Safety Evaluation Report

For the U.S. Army's Possession Only License for Depleted Uranium Penetrator Rounds at Jefferson Proving Ground, Madison, Indiana

License No. SUB-1435
Amendment No. 20

Office of Nuclear Material Safety and Safeguards

Figure 3-1. Diagram of the main features of the Army's RESRAD-Offsite analysis including the PCZ (yellow area) and SCZ (purple area). Reproduced from Figure 2-16 of the DP (Army, 2013a).

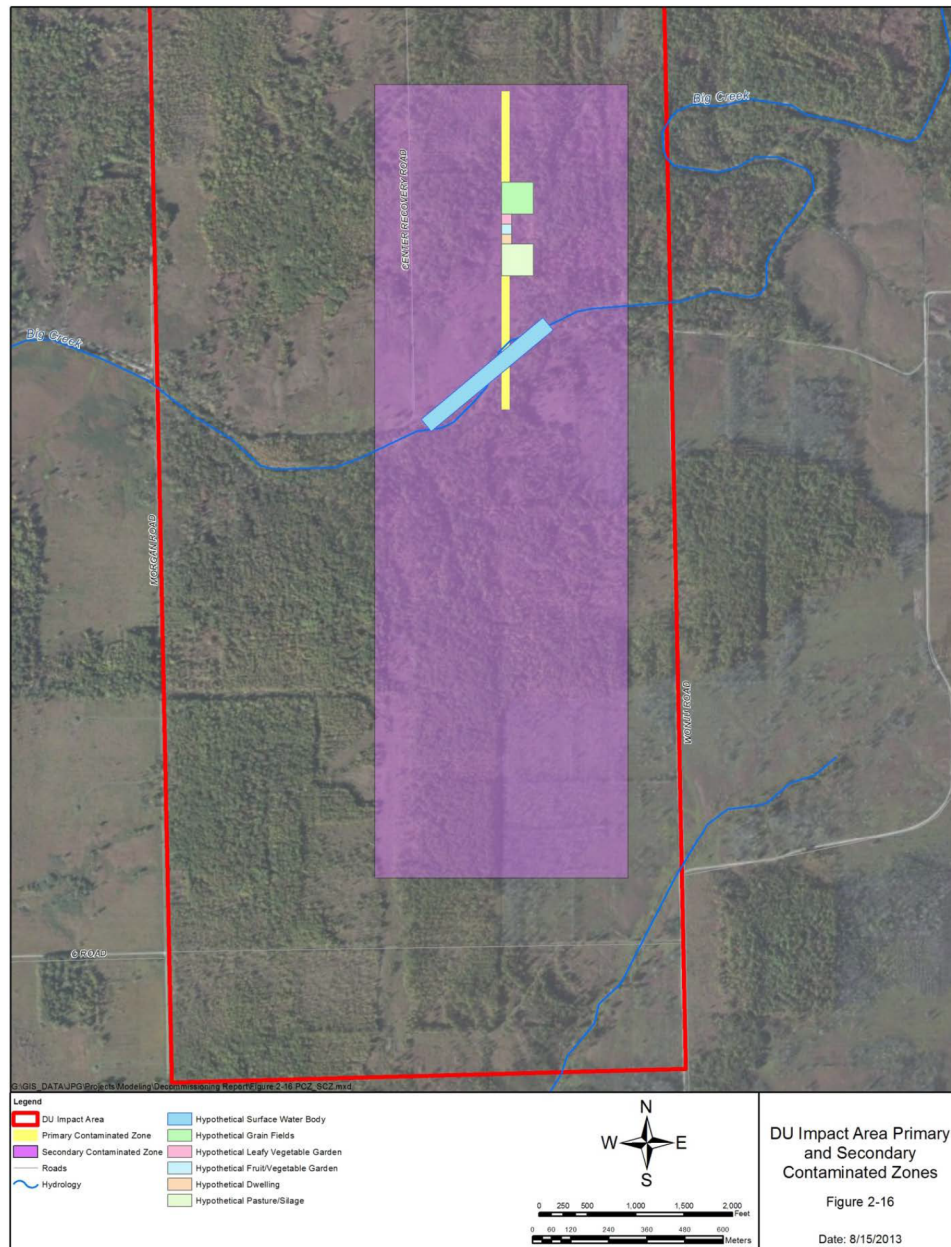
Regarding the second assumption, RESRAD-Offsite (Version 2.6) requires that each run contain only a single source term with a uniform concentration. The Army worked around this limitation by using multiple model runs for each scenario. For the onsite industrial worker, the sportsman/recreationalist, and the hypothetical onsite resident farmer, the Army used three models runs for the dose assessment: one representing the dose from the PCZ, and two model runs representing the contributions from left and right SCZs, respectively. The Army then added the projected doses from each of the model runs. The NRC staff found this approach to be acceptable because the effects of the contamination from the PCZ and SCZ would be additive.

The Army assumed the farm was aligned with the PCZ so that the dwelling, leafy vegetable garden, and garden of fruits and other vegetables occur entirely in the PCZ (orange, pink, and blue squares on Figure 3-1), while larger areas of grain cultivation and pasture, which exceed the width of the PCZ, are 25 percent in the PCZ and 75 percent in the SCZ (light green and green squares on Figure 3-1). The NRC staff found this approach to be acceptable because other reasonably foreseeable arrangements of the dwelling and agricultural areas are unlikely to result in a higher projected dose. As discussed in Section 3.2.2 of this SER, the NRC staff found the source term concentrations of uranium in the PCZ and SCZ to be acceptable because they were consistent with site-specific information. The Army represented the resident’s time outside on the PCZ, inside the house in the PCZ, and outside in agricultural areas in the SCZ
